Planning Commission Staff Report

MEETING DATE: SEPTEMBER 3, 2014

SUBJECT: Z13-08: GILBERT TOWN CENTER: REQUEST TO AMEND ORDINANCE NOS. 427, 617, 725, 1287 AND 1689 BY REMOVING FROM THE SETTLER'S POINT PLANNED AREA DEVELOPMENT (PAD) AND THE GILBERT TOWN CENTER PAD APPROXIMATELY 25.3 ACRES OF REAL PROPERTY GENERALLY LOCATED AT THE SOUTHEAST CORNER OF GILBERT ROAD AND WARNER ROAD ; TO APPROVE THE DEVELOPMENT PLAN FOR THE GILBERT TOWN CENTER PAD; AND TO REZONE FROM REGIONAL COMMERCIAL (RC) ZONING DISTRICT WITH A PAD OVERLAY TO REGIONAL COMMERCIAL (RC) ZONING DISTRICT WITH A PAD OVERLAY .

A1.10
SITE PLAN
PRELIMINARY

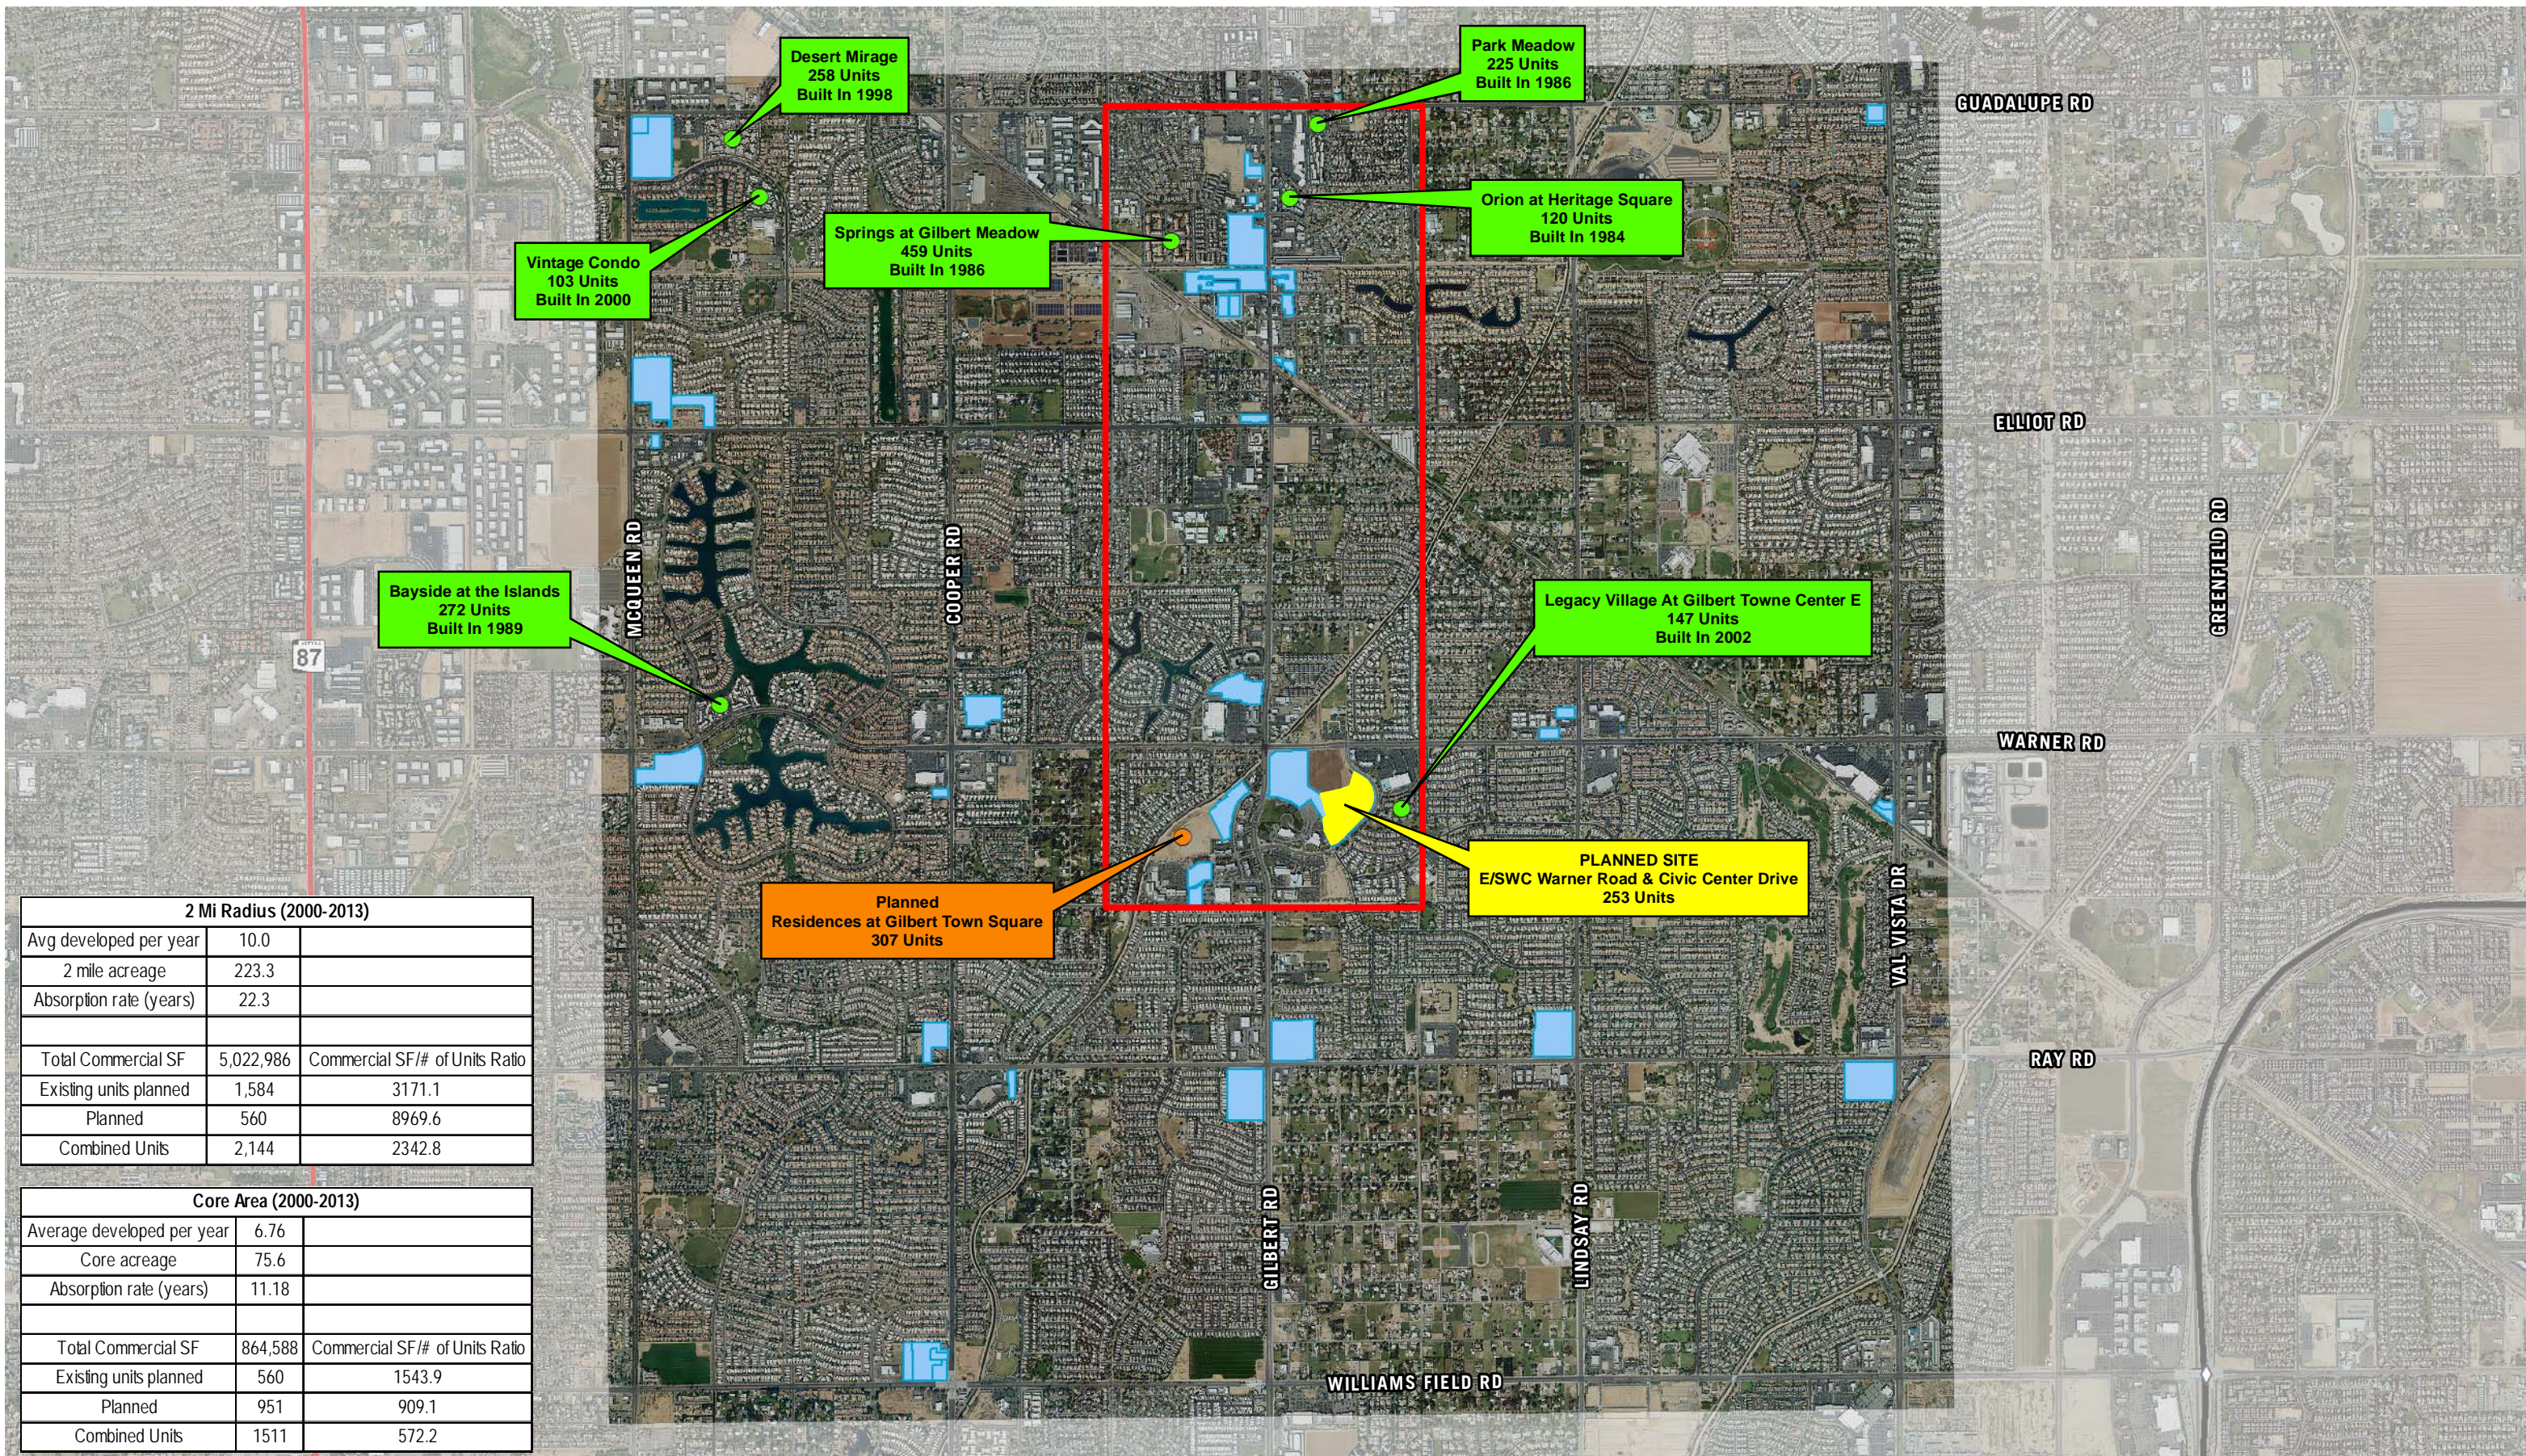
Staff finds that the proposed development plan provides a layout and design that relies predominantly upon automobiles for ingress and egress of the subject site and provides for a standard, stand-alone apartment complex design and does not meet demonstrate sustainability through compact design. The applicant has proposed a 6' wide decomposed granite pathway "fitness trail" is essentially the sole method of integration and outdoor gathering area between the proposed multi-family parcel and the remainder of the overall 37 acre site. This is the feature that the applicant believes complies with the use permit findings of fact related to compact design and pedestrian scale and orientation. A secondary decomposed granite pathway is shown on the use permit exhibits. The proposed parking for the apartment buildings does appear to comply with the parking requirements for multi-family residential uses under the LDC.

Staff believes that the proposed development plan exhibits do not provide for or meet the intent of this design requirement. The proposed development plan essentially creates a stand-alone multi-family development, predominately isolated from the remainder of the overall Gilbert Town Center site. The applicant has proposed a 6' wide decomposed granite fitness pathway in order to connect the municipal complex to the north between the Banner Health Center parcel and the proposed multi-family parcel as essentially the sole method of integration between the proposed multi-family parcel and the remainder of the overall 37 acre site.

The proposed project has not demonstrated appropriate vehicular and pedestrian connectivity that serves vehicles, pedestrians and bicycles. Staff notes that when the 13 acre Banner Health Center site was rezoned in May of 2012 under Ordinance No. 2368, the original intent was for Banner in coordination with the proposed multi-family parcel/ southeast parcel (Parcel 2) to develop and improve a drive aisle between the two parcels and provide a secondary vehicular connection between Palm Street and Civic Center Drive. This was the reason for creating the Banner Health Center parcel shape as it is and the remaining southeast parcel (Parcel 2). The proposal under Z13-08 no longer provides for this access drive and staff believes this further
